Addendum No. 2

PROJECT: ERBR-30(02) PARKERS LAKE BRIDGE, JACKSON COUNTY

DATE: NOVEMBER. 20, 2020

ERBRF PROJECT NO. ERBR-30(02), JACKSON COUNTY SHEET NO. 4

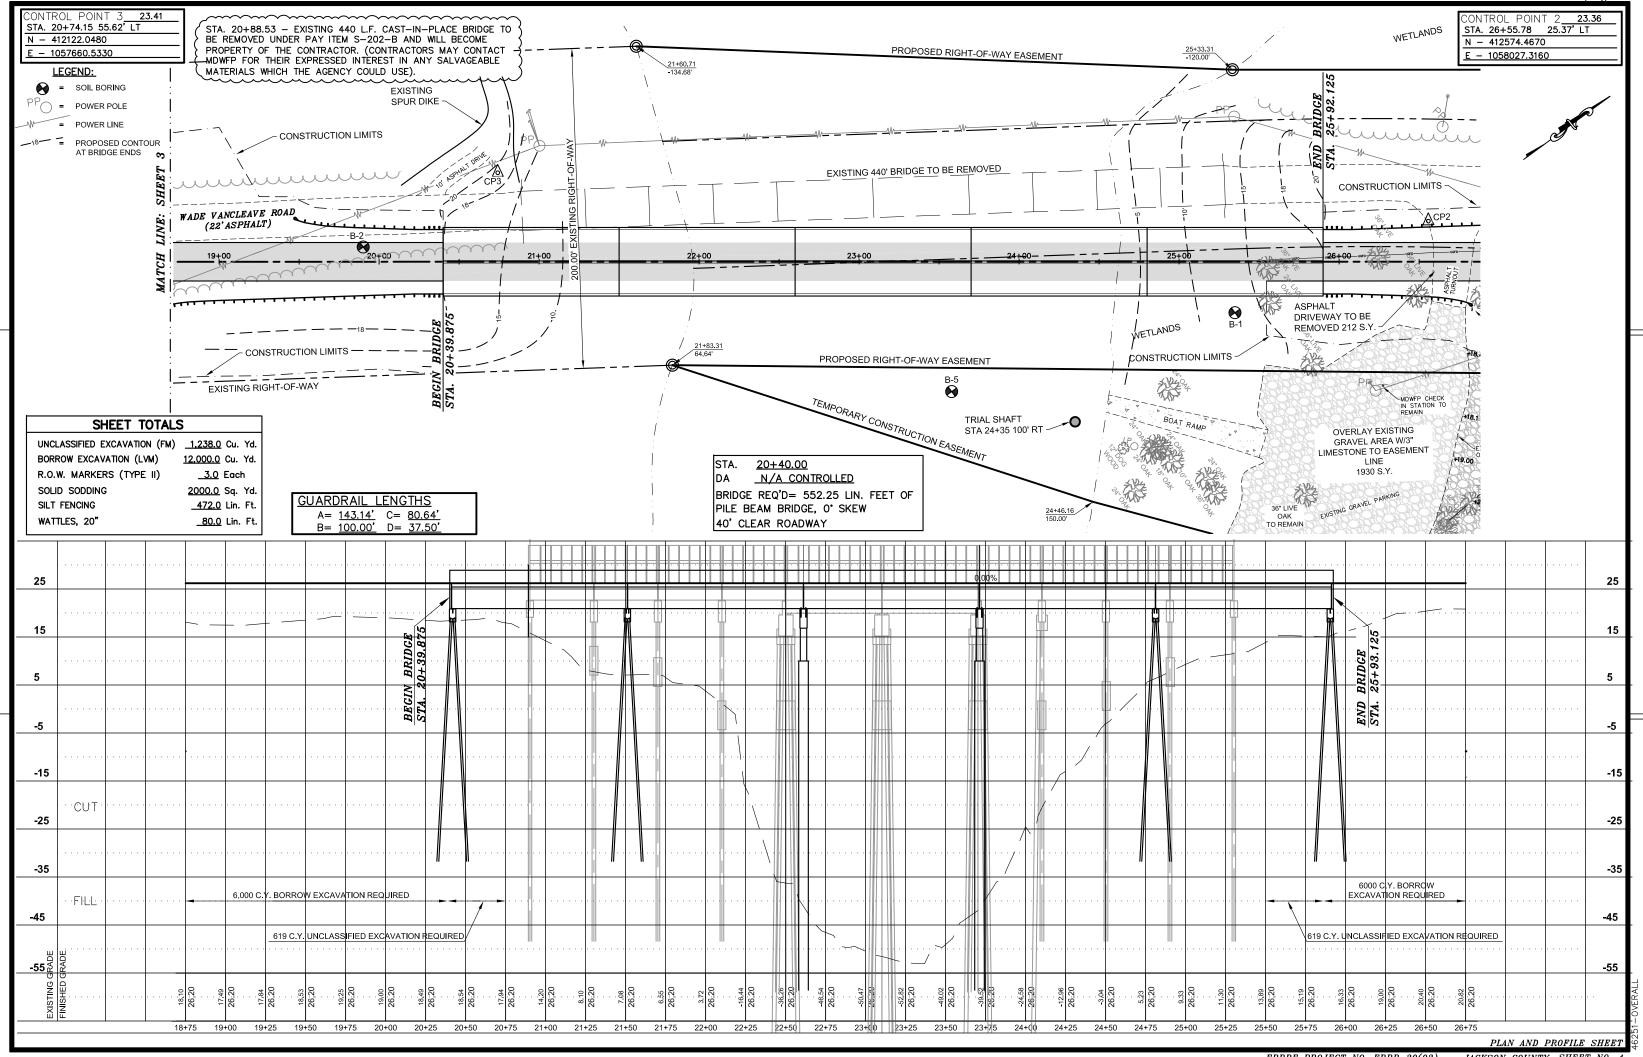
- 1. Contract time is being revised to a **320 WORKING** day contract. All references to contract time requirements shall be changed accordingly.
- 2. The bid date is being extended to **December 1, 2020**, to allow additional time for review of the following information being posted for the project. (time requirements for submittal of bids to remain unchanged).
- 3. Revise the bridge removal note on Sheet 4, as follows:

"Station 20+88.53 - Existing 440 L.F. CAST-IN-PLACE bridge to be removed under pay item S-202-B and will become PROPERTY OF THE CONTRACTOR." (Contractors may contact MDWFP for their expressed interest in any salvageable materials which the agency could use).

In this respect, a copy of the original bridge plans are being made available under the engineer's website at <u>www.batsonandbrown.com</u> for contractors review and use in planning removal work requirements.(Note wherein the original pile depths as installed under SAP-30(1) were reduced due to scour and a maintenance project SAP-30(5)M installed the pipe piles to reinforce the existing substructure.)

Removal of existing piles to be made at the existing mulline for all areas in the channel and a minimum of 3' below the mulline all other areas.
